Addendum 1

ITB-12-06

CITY OF WINTER HAVEN
 REPLACEMENT OF LIFT STATION 110

LS-110
 LIFT STATION DETAILS

Control terminal blocks shall be of the clamp screw type, rated for 600 volts. Amperage rating shall accommodate the control circuit amperage. An additional 4 space terminal strip shall be installed in the cabinet for future use, with RTU equipment.

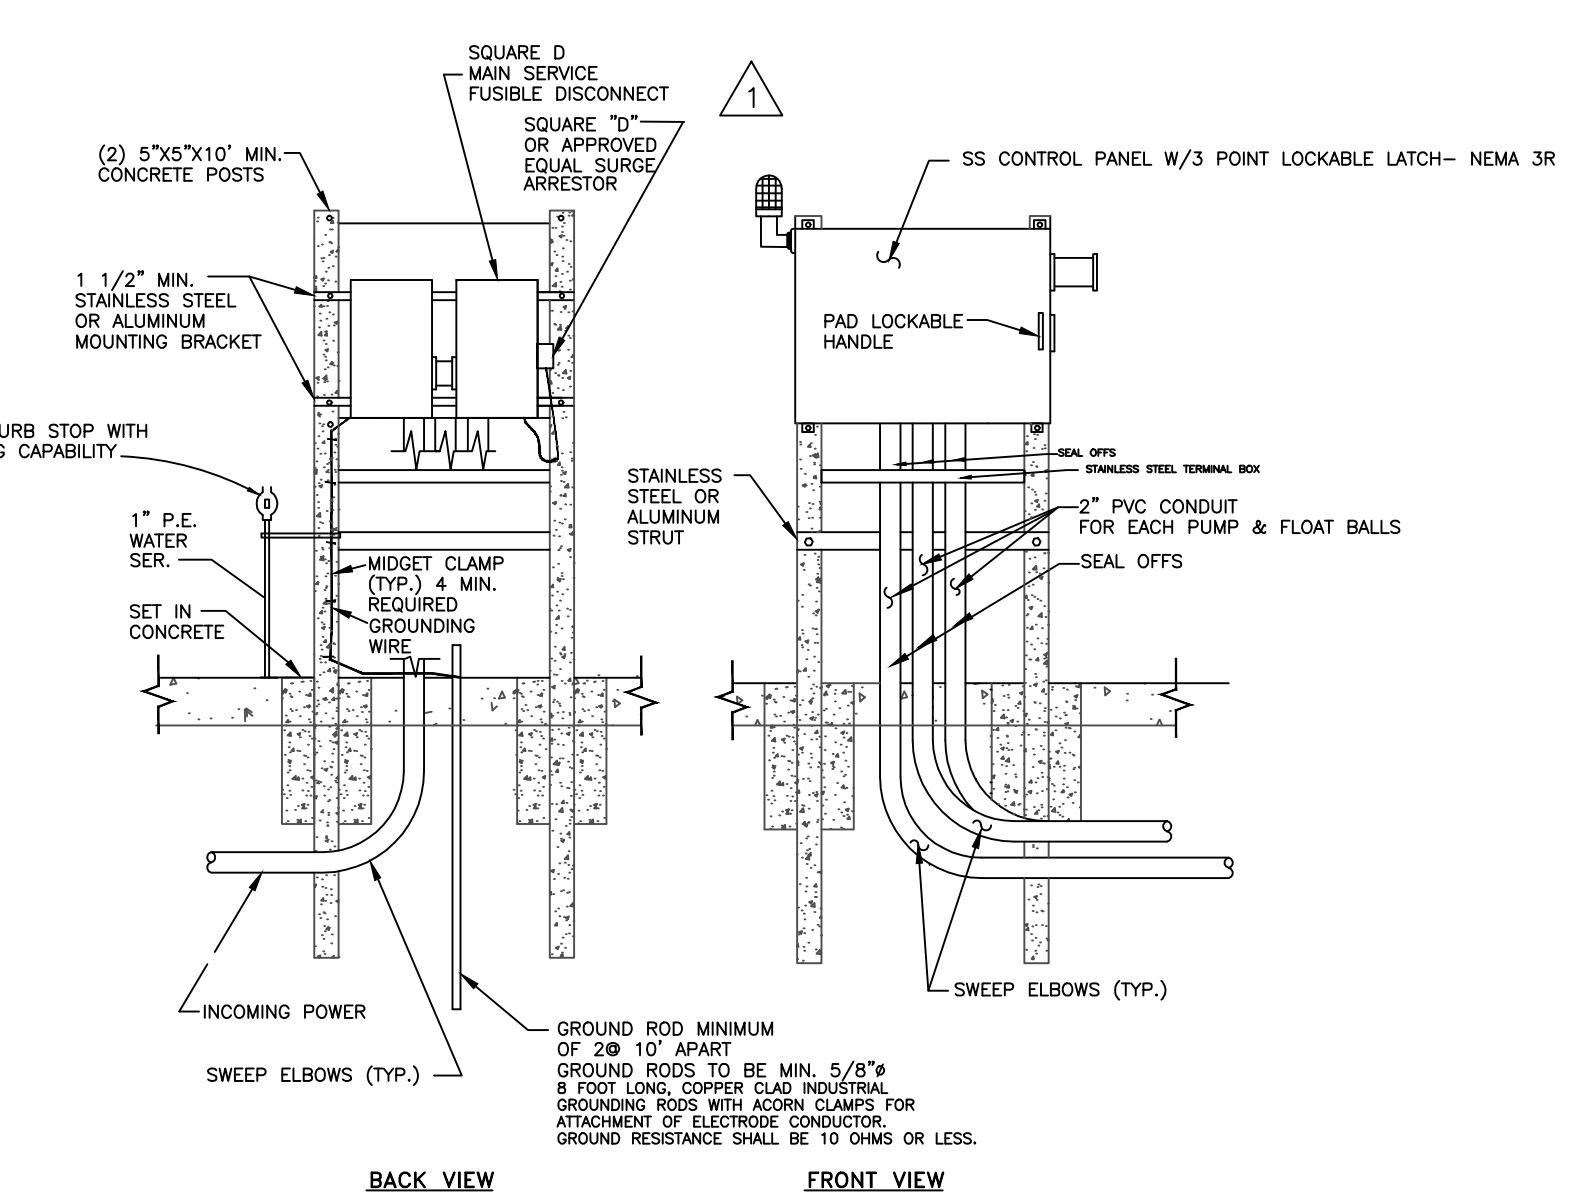
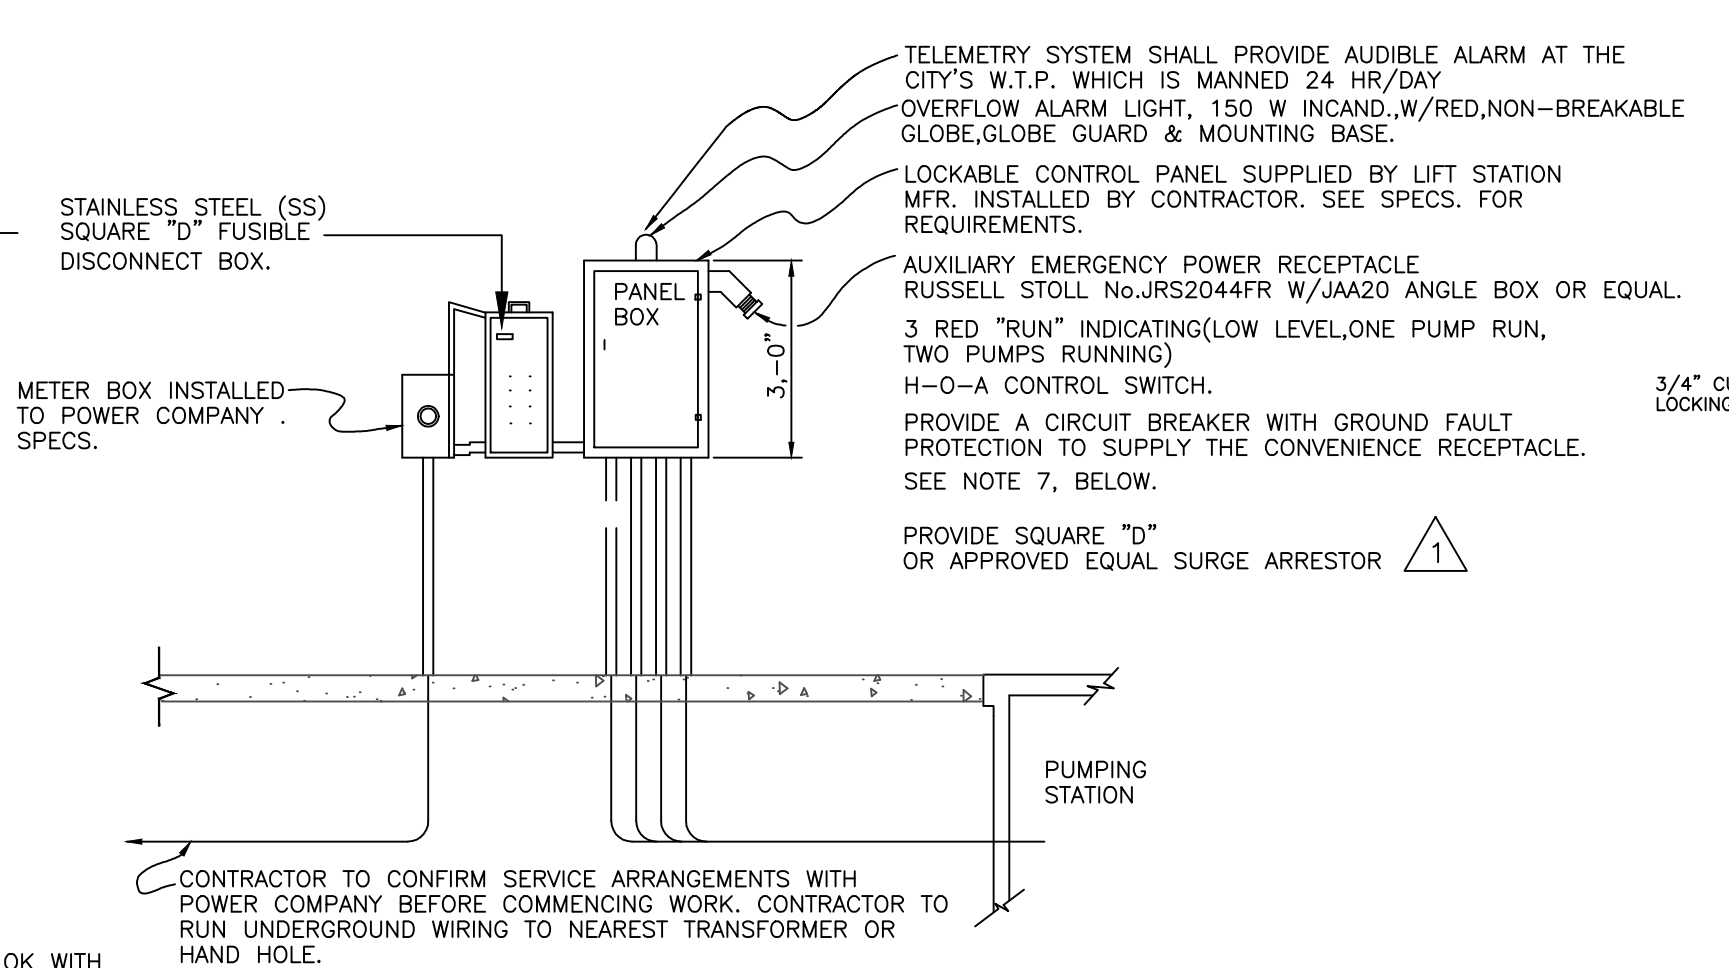
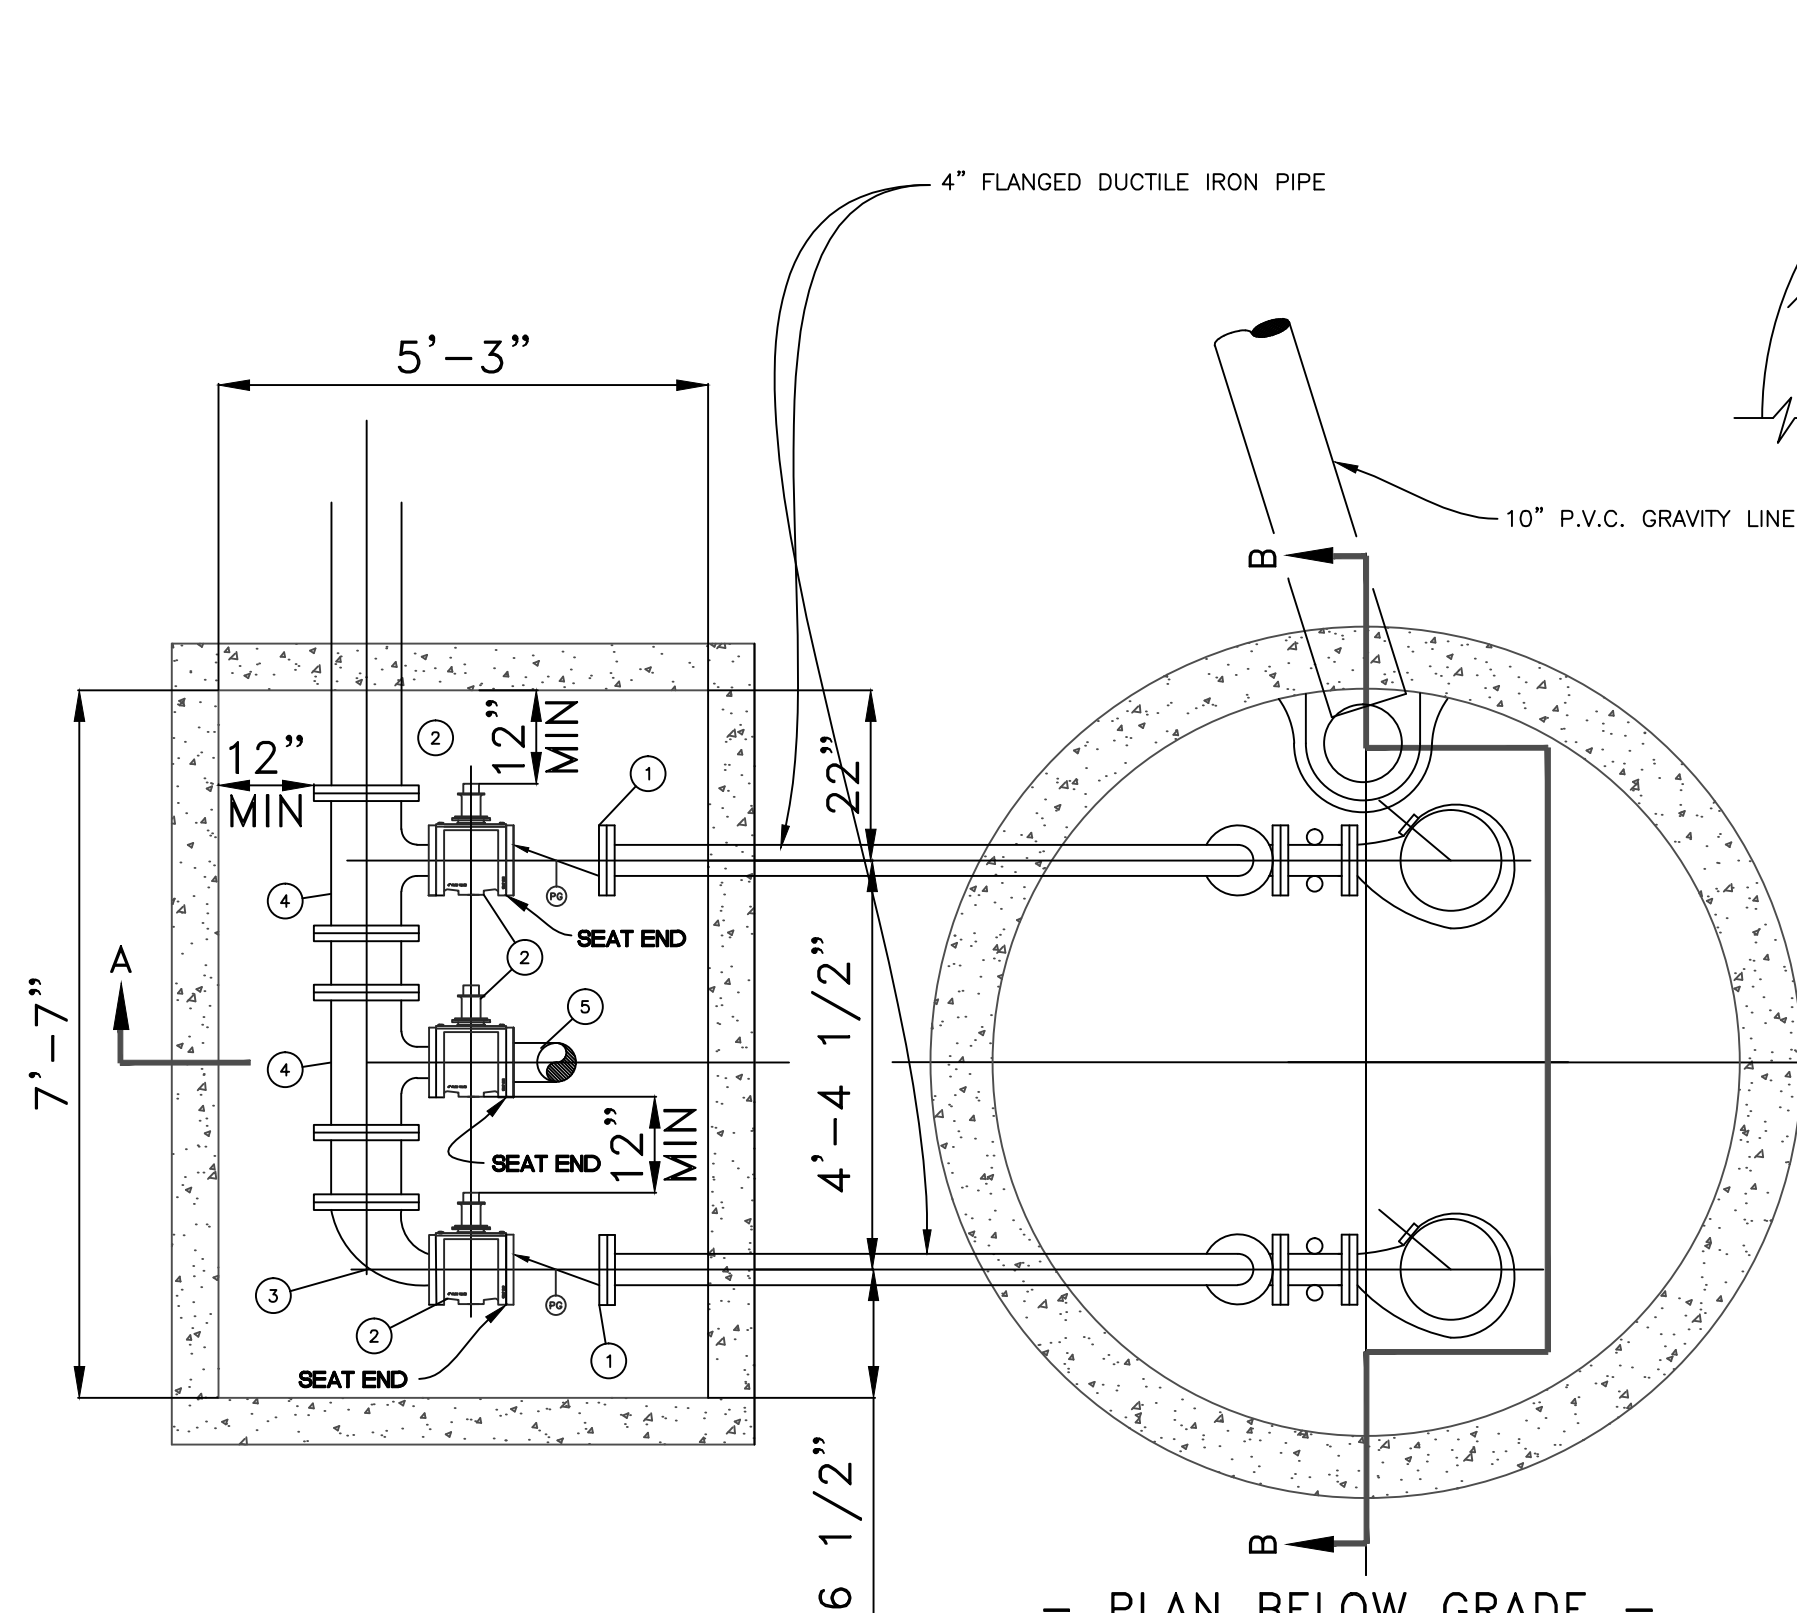
1. **Surge Arrestor/Protector:** The City does not supply the surge arrestor; it shall be furnished by the Contractor. The plans (Sheet 5) and the Specifications (Section 6.9.9.4) have been revised to show and specify a Square “D” type surge protector or approved equal instead of the Volt Guard Type VGX that was previously specified. The surge protector shall be connected to the load side of the main service breaker and located externally on the main disconnect box. Refer to the accompanying revised Sheet 5 of the plan set and page number 6-20 of the Specifications.

A Square "D" type surge protector or approved equal shall be included and wired to protect motors and control equipment from induced line surges. The surge protector shall be connected to the load side of the main service breaker and located externally on the main disconnect box. Revised 11/08/2011
